North York Moors National Park
Planning Department
Helmsley
Attn Mr A Muir
ref: NYM/2007/0859/FL/INV

12th Nov 2007

**Newbiggin High Farm Aislaby, Whitby
Application for Siting of a wind turbine:**

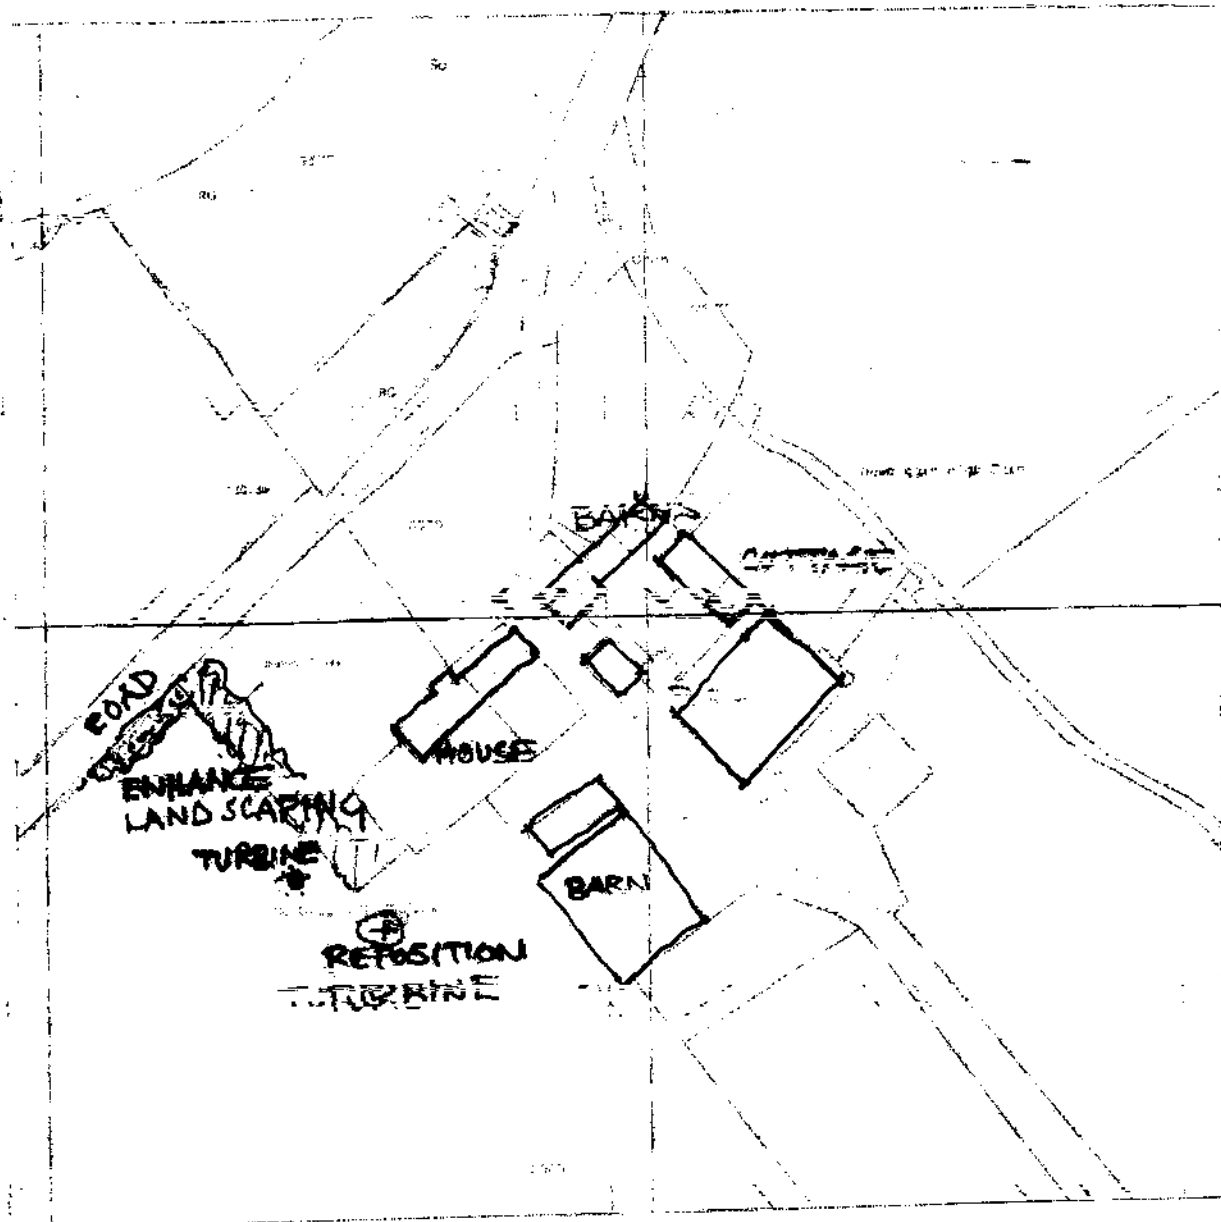
With regards your letter of the 24/10/2007 & our subsequent conversation we would agree to an adjustment of the position of the turbine in order to reduce its impact on passers-by on the adjacent high level unclassified road to Egton.

As suggested we can align it to be set against the large barns & other farm buildings which would form a backdrop from the road approaching in the Aislaby direction. The current tree planting on the edge of the garden will mature to form a more substantial screen, blocking vision as people pass towards Egton. The re-positioning lowers the mast by approx 1.5 mtrs. I enclose further photographs to illustrate this & a revised plan.
